Access Compliance Report Public Rights-of-Way (Curb Ramps)

Main Street: CHIQUITA_CANYON_DR Cross Street: AIROSO_ST Location: N

ADA ID: RPRK211124130814 Ramp Type: Type 1 - Perpendicular Initial Pass/Fail: Fail Overall Compliance: No Severity Score: 0

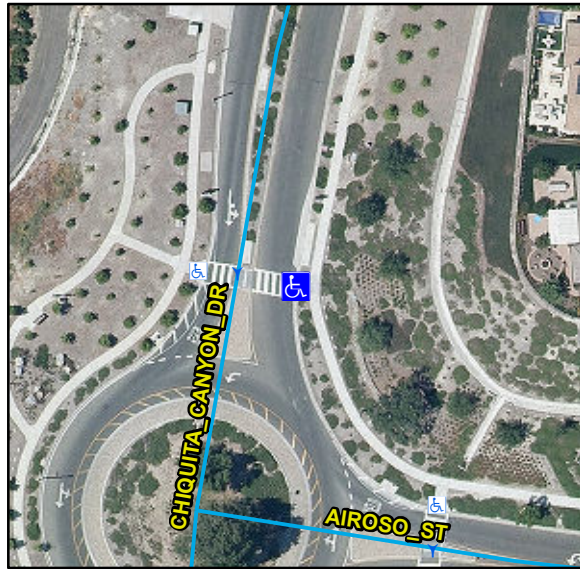
Compliance	Description	Data	Compliance	Description	Data
N/A	Ramp Length (in)	70	N/A	Flare Type LT	
Yes	Ramp Width (in)	60			N/A
Yes	Ramp Run Slope (%)	6.7	N/A	Flare Slope LT (%)	N/A
Yes	Ramp Cross Slope (%)	3.5	N/A	Flare Traversable LT	N/A
N/A	Landing Present	N/A	N/A	Flare Type RT	
N/A	Landing Length (in)	N/A			N/A
N/A	Landing Width (in)	N/A	N/A	Flare Slope RT (%)	N/A
N/A	Landing Run Slope (%)	N/A	N/A	Flare Traversable RT	N/A
N/A	Landing Cross Slope (%)	N/A	N/A	DWS Provided	N/A
N/A	Landing Movement Obstructed?	N/A	N/A	DWS Contrast	N/A
	Landing Movement Type	N/A	N/A	DWS Length (in)	N/A
N/A	Landing Shared	N/A	N/A	DWS Full Width	N/A
N/A	Clear Space	N/A	N/A	DWS Offset Left (in)	N/A
N/A	Clear Space To Crosswalk (in)	N/A	N/A	DWS Offset Right (in)	N/A
N/A	Marked Crosswalk 1	Yes	N/A	Marked Crosswalk 2	N/A
	Crossing 1 Direction	W		Crossing 2 Direction	N/A
	Marked Crosswalk 1 Width (in)	144		Marked Crosswalk 2 Width (in)	N/A

N/A	Ramp Inside Crosswalk 1	Yes	Yes	Ramp Inside Crosswalk 2	N/A
	Crossing 1 Slope (%)	5.1		Crossing 2 Slope (%)	N/A
	Crossing 1 Cross Slope (%)	4.9		Crossing 2 Cross Slope (%)	N/A
N/A	Gutter Ponding	N/A	No	Curb Slope	8.2
Yes	Gutter Lip Height (in)	0		Road Run Slope (%)	N/A
N/A	Gutter Run Slope (%)	N/A		Road Cross Slope (%)	N/A
N/A	Gutter Cross Slope (%)	N/A			
Yes	Overall Surface Condition: Acceptable		Yes	Perp Joint Present	Yes
	Cross Gutter Present?	No		Spandrel Present?	No
	Replace Cross Gutter?	N/A		Replace Spandrel?	N/A

Remove & Replace Entire Ramp.

R304.2.2, STD 1115
